# UNITED STATES PATENT AND TRADEMARK OFFICE

APPLICATION NO.	FILING DATE	FIRST NAMED INVENTOR	ATTORNEY DOCKET NO.	CONFIRMATION NO.
10/623,404	07/21/2003	Edgar Vicente Chiquin		1067

<b>Office Action Summary</b>	<b>Application No.</b> 10/623,404	<b>Applicant(s)</b> CHIQUIN, EDGAR VICENTE	
	<b>Examiner</b> James O. Hansen	<b>Art Unit</b> 3637

## **DETAILED ACTION**

FIGURE 5

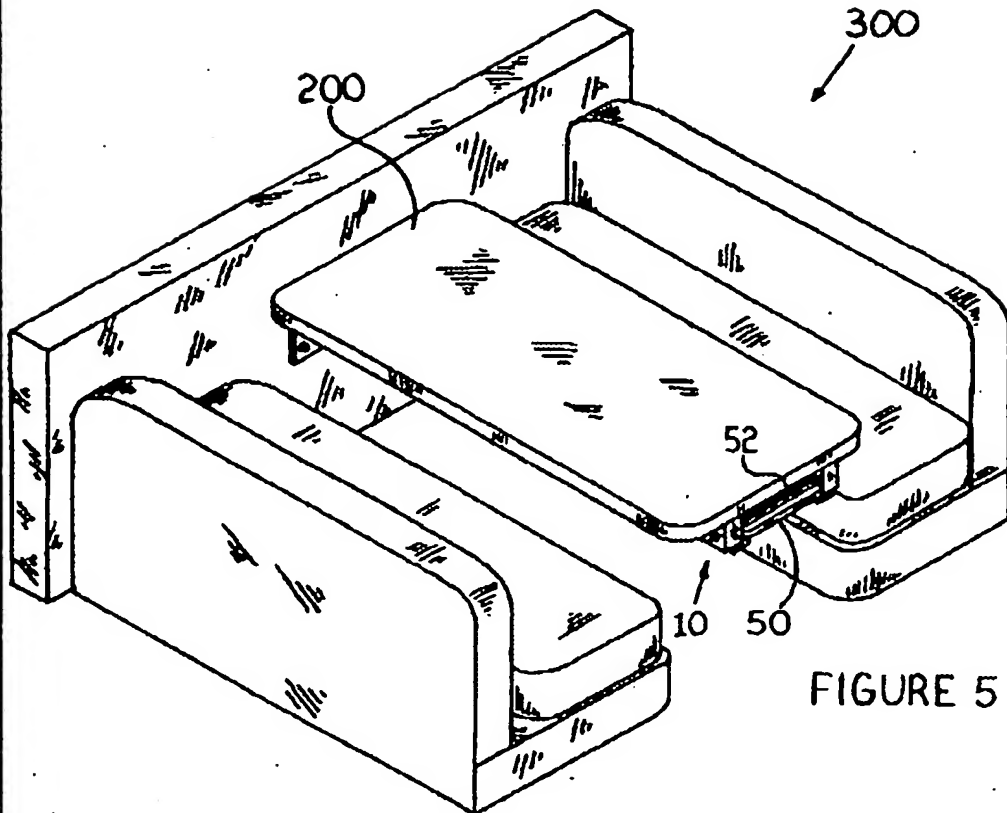
1. The drawings were received on April 20, 2005. These drawings are disapproved by the examiner [see note below].

Not Extended  
for 8/19/05

FIGURE 6

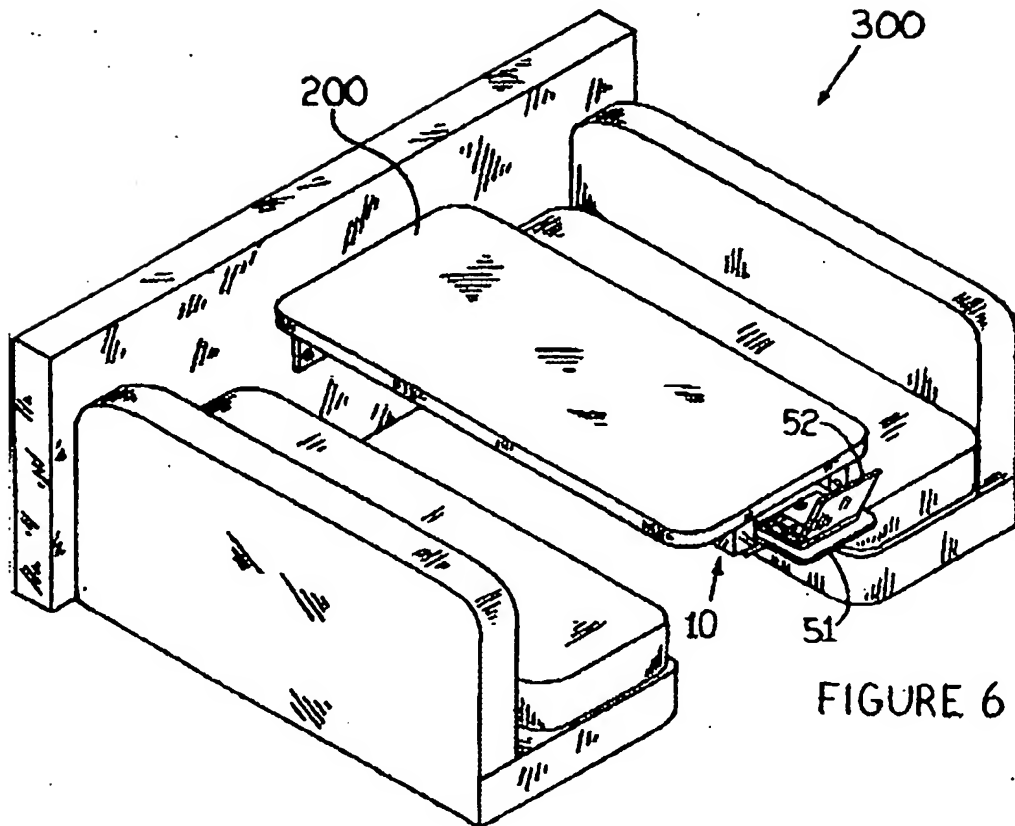
Not Entered  
Apr 21/05
